Access Compliance Report

Public Rights-of-Way

(Curb Ramps)

Intersection ID: 14286	Main Street: S_TORRENCE_ST	Cross Street: MAIN_ST	Location: W
ADA ID: D4B85E64E5D3	Ramp Type: PerpDiag	Initial Pass/Fail: Fail	Overall Compliance: No
			Severity Score: 13.75

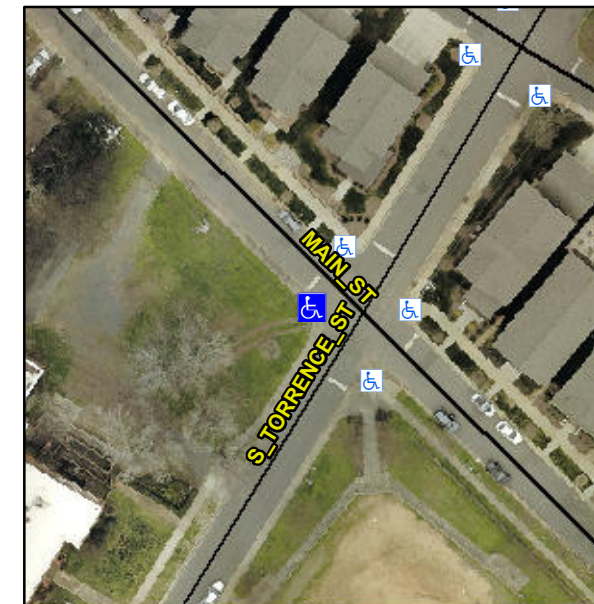
Not Found, R304.2.2, R304.5.3

Compliance	Description	Data	Compliance	Description	Data
N/A	Ramp Length (in)	51.0	No	Ramp Slope (%)	8.9
Yes	Ramp Width (in)	48.0	No	Ramp XSlope (%)	2.4
N/A	Flare Type LT	N/A	N/A	Flare Type RT	N/A
N/A	Flare Slope LT (%)	N/A	N/A	Flare Slope RT (%)	N/A
N/A	Flare Traversable LT?	N/A	N/A	Flare Traversable RT?	N/A
N/A	Landing Length (in)	N/A	N/A	DWS Provided?	N/A
N/A	Landing Width (in)	N/A	N/A	DWS Contrast?	N/A
N/A	Landing Slope (%)	N/A	N/A	DWS Length (in)	N/A
N/A	Landing X Slope (%)	N/A	N/A	DWS Full Width?	N/A
N/A	Landing Curb? (Y/N)	N/A	N/A	DWS Offset (in)	N/A
N/A	Shared Landing?	N/A			
N/A	Gutter Ponding?	N/A	N/A	Gutter Slope (%)	N/A
N/A	Gutter Lip Ht (in)	N/A	N/A	Gutter X Slope (%)	N/A
N/A	Painted X Walk1?	No	N/A	Painted X Walk2?	No
	X Walk 1 Direction	To SE		X Walk 2 Direction	To NE
N/A	X Walk 1 Width (in)	N/A	N/A	X Walk 2 Width (in)	N/A
	X Walk 1 Slope (%)	3.2		X Walk 2 Slope (%)	4.0
	X Walk 1 X Slope (%)	1.3		X Walk 2 X Slope (%)	1.1

Remove & Replace Curb Ramp With Two New Directional Ramps or Equivalent.
